# UNITED STATES PATENT AND TRADEMARK OFFICE

APPLICATION NO.	FILING DATE	FIRST NAMED INVENTOR	ATTORNEY DOCKET NO.	CONFIRMATION NO.
10/754,394	01/09/2004	Michael Frank Walsh	WMFR-P01-001	9186

## Office Action Summary

## **DETAILED ACTION**

FIG.1.

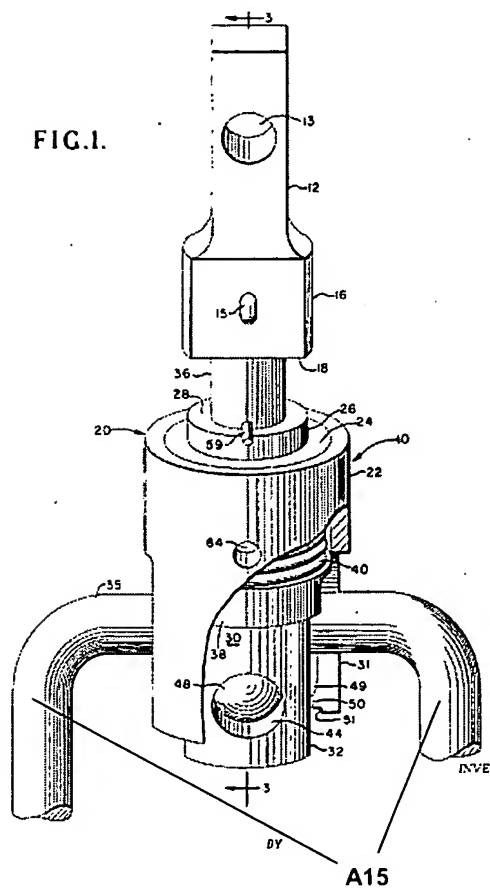
Regarding claim 1, Cannon, Jr., discloses, in Figures 1 and 3, a low-force release mechanism comprising a main structure **20**, a trap **32**, an internal spring activation element **38,40,36**, at least one trigger **59**, and attachments **A15**. A load force **A10** is distributed away from the trigger **59**. An internal release activation element **36** comprises the release pin **36** and one or more ball bearings **46,48** or slugs interacts with an internal geometry **44** of the trap **32**. The internal spring activation element **38,40,36** comprises an internal spring pin **38**, an internal spring **40**, and a release pin **36**. However, Cannon, Jr. fails to disclose a container attached to the main structure **20** and the trap **32**. Eakin teaches, in Fig. 1, a low-force release mechanism a container attached to a main structure **20** and a trap **32** to be released from being carried.

Regarding claim 9, Cannon, Jr. discloses, in Figures 1 and 3, a low force release mechanism comprising a main structure **20**, a trap **32**, and internal spring activation element **38,40,36**, at least one trigger **59**, and attachments **A15**. The internal spring activation element **38,40,36** comprises an internal spring pin **38**, and internal spring **40**, and a release pin **36**. A load force **A10** is distributed away from the trigger **59**. The internal release activation element **36** comprises the release pin **36** and ball bearings **46,48** or slugs interacts with an internal geometry **44** of the trap **32**. However, However, Cannon, Jr. fails to disclose a container attached to the main structure **20** and the trap **32**; and a string attached to the trigger **59**.
